Montecito Marketplace-Phase II Update #3

CITY OF LAS VEGAS		DATE:
INTER-OFFICE MEMORANDUM		November 7, 2013
TO: Land Development Services Department of Public Works		FROM: Albert Sung, P.E. Flood Control Project Engineer Department of Public Works
SUBJECT:	Drainage Study for:	
	Montecito Marketplace - Phase II (Pad R) (Update #3 to develop for Smith's Fuel Center)	
Cross Streets:	NEC of Durango Drive & Dorrell Lane	COPIES TO: Great Basin Engineering
File Number:	F:\Depot\DSMemos\DS3950F.doc	Montecito Companies
Parcel Number:	125-20-510-007; -011 & -012	Bart Anderson, P.E., DevCo
Zoning Action:	SDR-11702 & VAR-11710	
FEMA Flood Zone	YES	NO X
Proposed Storm Drain	YES	NO X

Montecito Marketplace - Phase II (Pad R)
(Update #3 to develop for Smith's Fuel Center)

Update #3
to the
Technical Drainage Study
for
Montecito Marketplace-Phase II

Hydraulic Section from Original Study – 10 & 100 Year

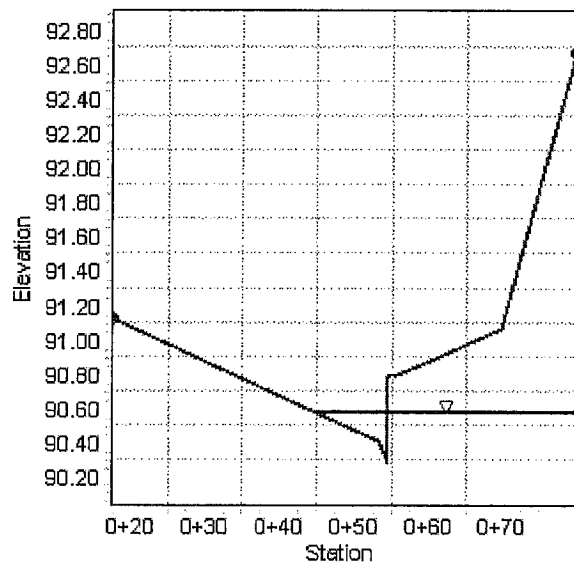
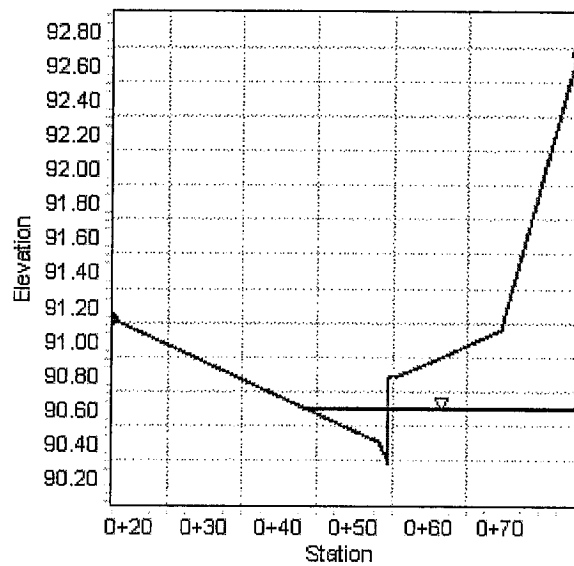
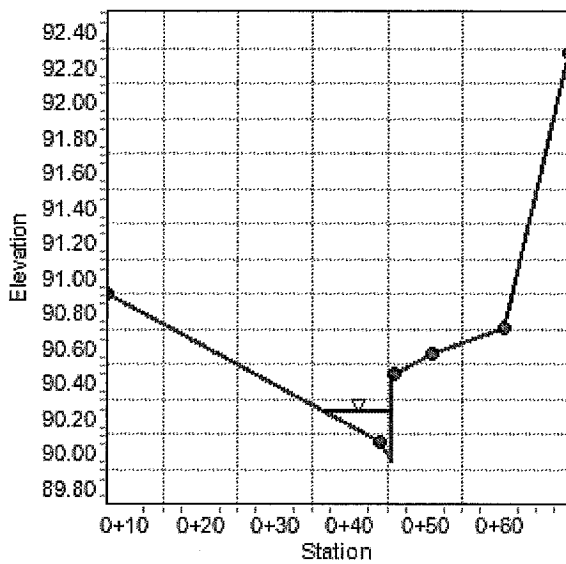
From the original study, it was determined that the flow in the existing Durango Drive at this location was 2 and 3 cfs for a 10 and 100-year storm, respectively. The 10-year depth of flow for both sections was 0.29 feet and the 100-year depth was 0.32 feet. The retaining wall was already designed as a part of the previous study and has not changed. Durango Drive is an existing street and no changes to the roadway have occurred since the original study. An updated cross section (Section A) has been included which reflect the new layout of the fuel center attendant kiosk. This cross section can be found on the detail sheet included with this letter. A hydraulic cross section of Section A, which contains the section of Durango Drive adjacent to fuel center, has been attached for reference. This section is comparable to Section G from the original study, but is slightly different due to the new site layout. The hydraulic cross section of Section G from the original study has also been included for comparison. Section A results in slightly lower

flow depth for the 10-year event of 0.28 ft and the same flow depth of 0.32 ft for the 100 year event. Since the depth of flow has essentially remained the same and the height of the wall has remained the same as in the original study, the building is still well protected from the flows in Durango Drive even with the slightly lower finish floor elevation.

23 Oct, 2013
SHEET NO.
C2.1

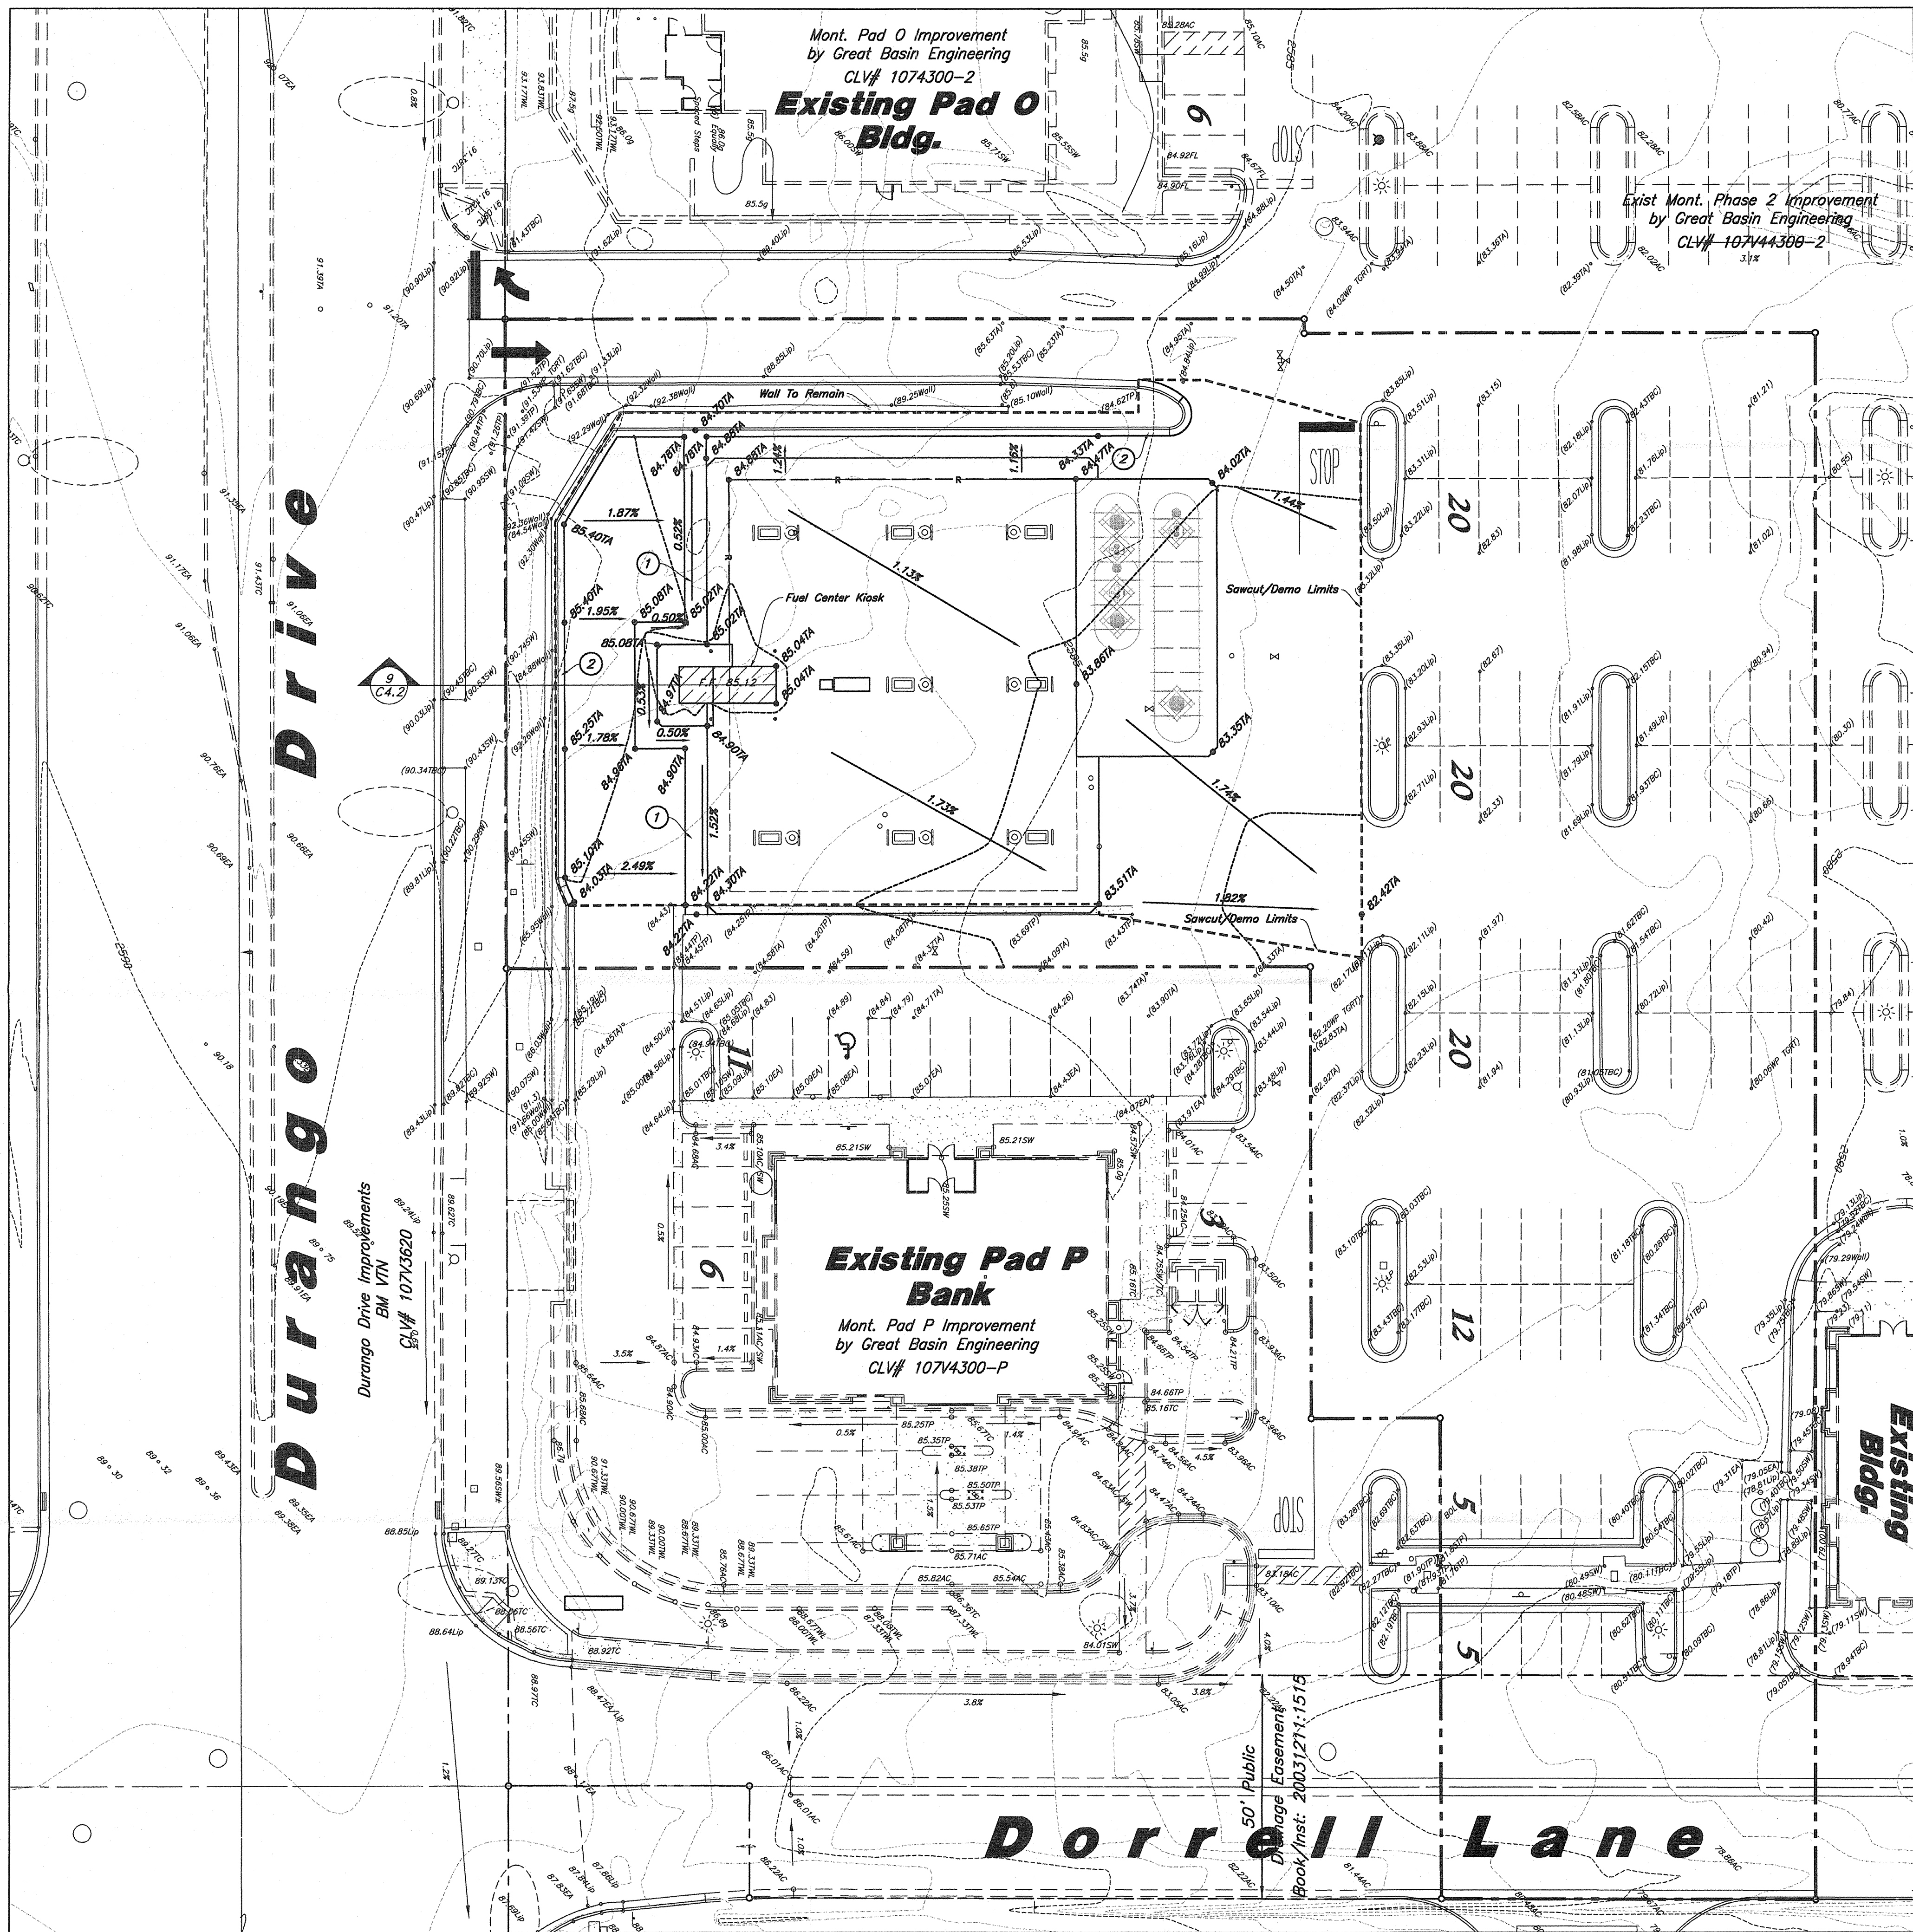
The only change in the design is that the proposed finish floor elevation of the fuel center's attendant kiosk (2585.12) is slightly lower than the Johnny Carino's finish floor elevation (2585.25) provided in the original study. However, the area still maintains positive drainage away from the building and is still protected to well over twice the depth of flow in Durango Drive by the adjacent retaining wall. The grading plan and detail sheet containing the revised cross sections for Building R have been attached.
